THE COMPETITION-1997

TEAM UPDATE #1

Date: January 14, 1997

CORRECTIONS AND UPDATES TO THE MANUAL

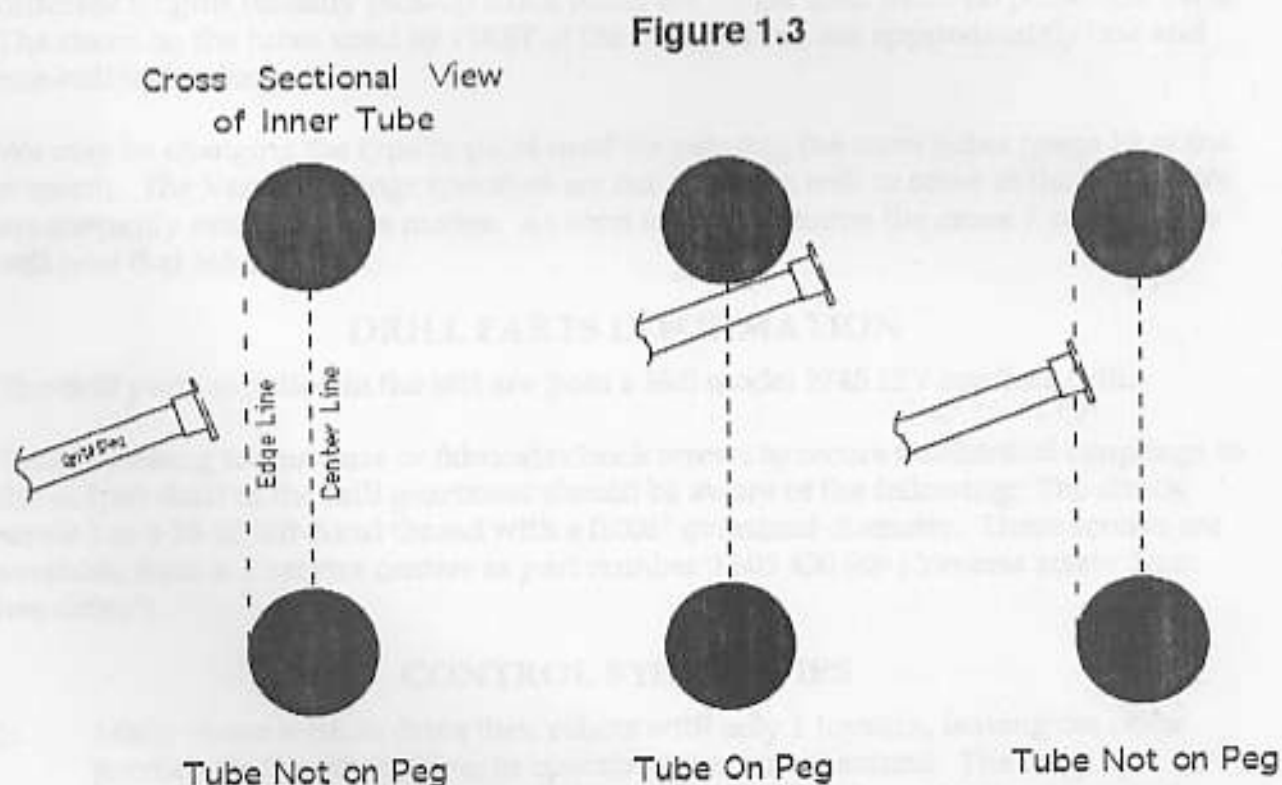
Figure 1.3 incorrectly shows the status of tubes with respect to scoring position. Below is the corrected Figure 1.3.

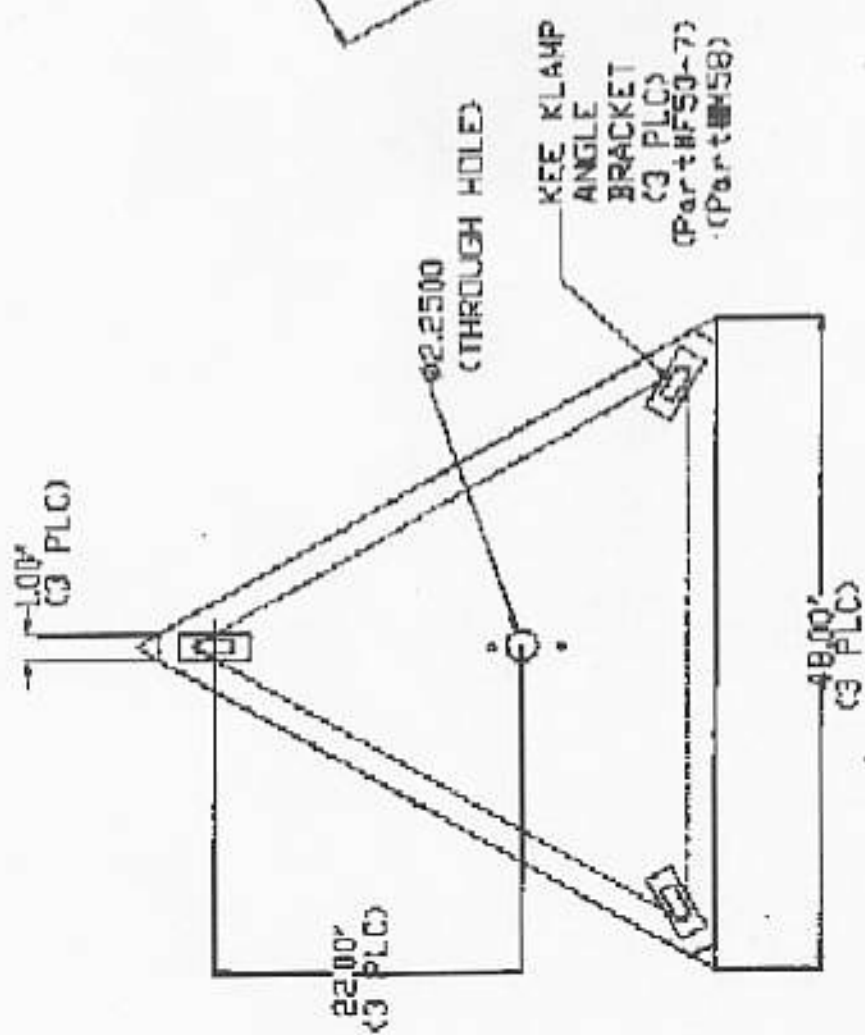
The following figure was accidentally omitted from Section 2.

GOAL BASE

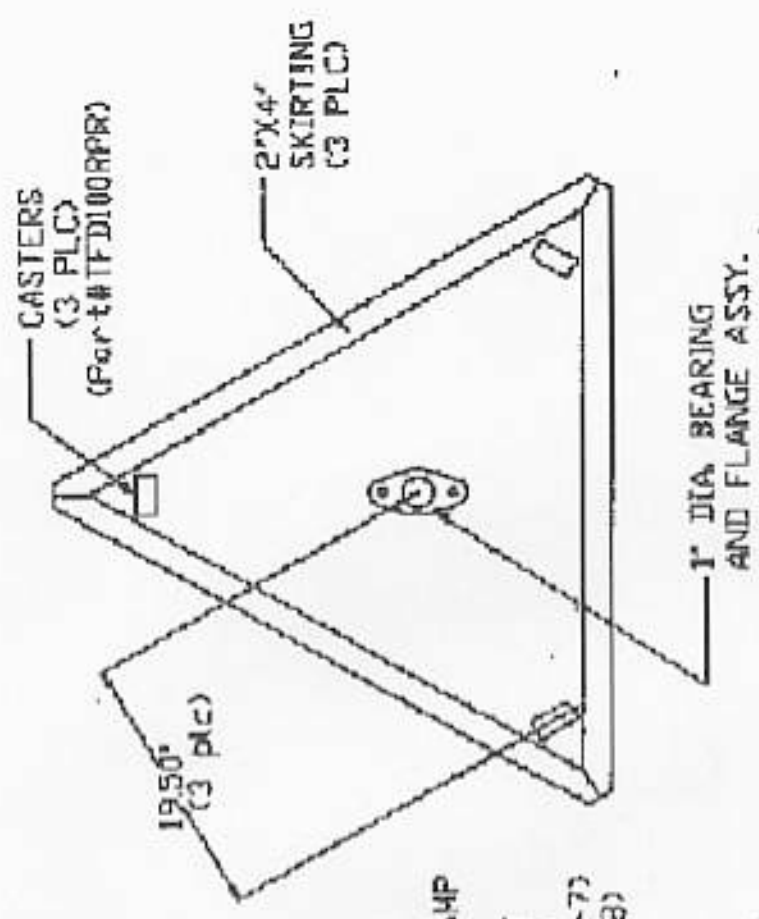
The 1" clearance shown between the bottom edge of the skirt of the triangular base of the goal and the surface of the caster unit wheels is incorrect. This dimension (Goal Elevation and Detail Section Goal Base views) should be 1 9/16". When the goal is in position on the circular base, the clearance between the bottom of the skirt and the surface of the aluminum disk will be approximately 1 9/16".
